UNITED STATES PATENT AND TRADEMARK OFFICE

Office Action Summary

10/590,176

DETAILED ACTION

Figure A: Fig. 8 of Dalakian, U.S. Patent 5,222,409

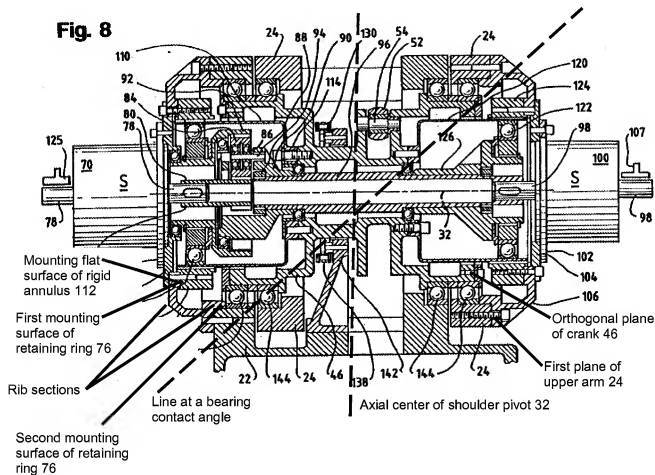
a rotation output section (crank 46, col. 6, line 40, and fig. 8) having an orthogonal plane orthogonal to the axial line of the turning pivot (orthogonal plane of crank 46, see fig. A below),

the turning arm has a first plane connected to the plane of the rotation output section (first plane of upper arm 24, see fig. A below) and a second plane connected to the heavy object, positioned nearer to the heavy object from the axial line of the turning

the axial center of the turning pivot of the heavy object (axial center of shoulder pivot 32, see fig. A below) is positioned within a distance between one of the pair of ball bearings, which is positioned on the orthogonal plane side of the rotation output section, and an intersection obtained by crossing the axial line of the turning pivot with a line at a bearing contact angle to the perpendicular line of the one ball bearing (line at a bearing contact angle, see fig. A below).

the fixing section of the planetary gear type speed reducer has a circular outside-diameter section (see fig. 8) and a mounting flat surface parallel to the plane of the rotation output section (mounting flat surface of rigid annulus 112, see fig. A below);

a first mounting surface for mounting the mounting flat surface of the fixing section of the planetary gear type speed reducer (first mounting surface of retaining ring 76, see fig. A below),

a second mounting surface for mounting the frame and orthogonal to the first mounting surface (second mounting surface of retaining ring 76, see fig. A below), and

a pair of rib sections for connecting outer both ends of the first mounting surface with outer both ends of the second mounting surface (rib sections, see fig. A below); and

the outside-diameter section of the mounting flat surface of the fixing section of the planetary gear type speed reducer is cut so that its side of the pair of ribs may be shorter than the circular outside diameter (see fig. A below).
